ENGINEERING CHANGE BULLETIN # 10014

.156" Pitch Male Connector Design Improvement

__M__MMR(MN)_, (Dwg# 10074) __M__MMW(MS, MM)_, (Dwg# 10075) __M__MMA(MV, MB, MD, MJ, MK)_, (Dwg# 10076)

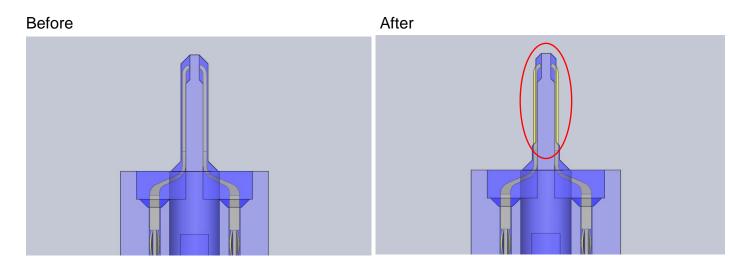
Removed plastic material that projected above contact area to improve mating contact resistance and to eliminate the possibility of intermittent contact between male and female connectors.
